RE: MEDINA COUNTY
CITY OF MEDINA
LEDGES OF SHARON SUB-DIVISION
NPDES PERMIT NO. OHC000003
OHIO EPA PERMIT NO. 3GC05404*AG
CONSTRUCTION STORM WATER

NOTICE OF VIOLATION

Figure 3. Equipment is being moved through wooded areas adjacent to wetlands on both sides. The disturbed path is eroding into the wetlands.

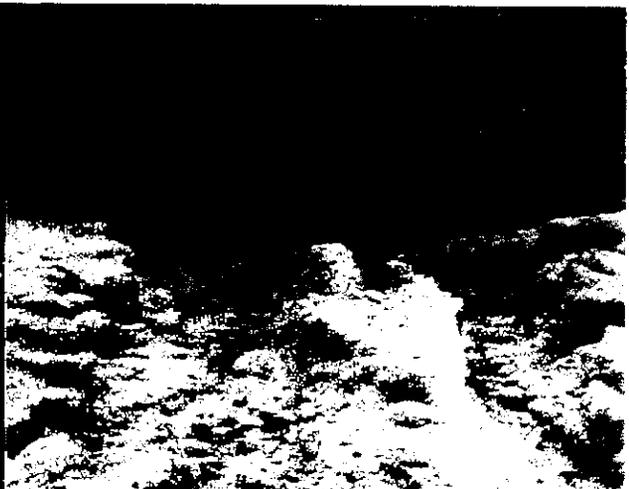
- **Failure to protect Surface Waters of the State.**
 - This is a violation of Part III.G.2.d.v. of the NPDES permit. There were inadequate erosion and sediment controls protecting the stream that crosses through the property, the pre-existing lakes (See Figures 1 & 2), as well as adjacent delineated wetland areas on site. There were areas where equipment was being moved through wooded areas and excessive amounts of sediment were eroding into the designated wetlands (See Figures 3 & 4).
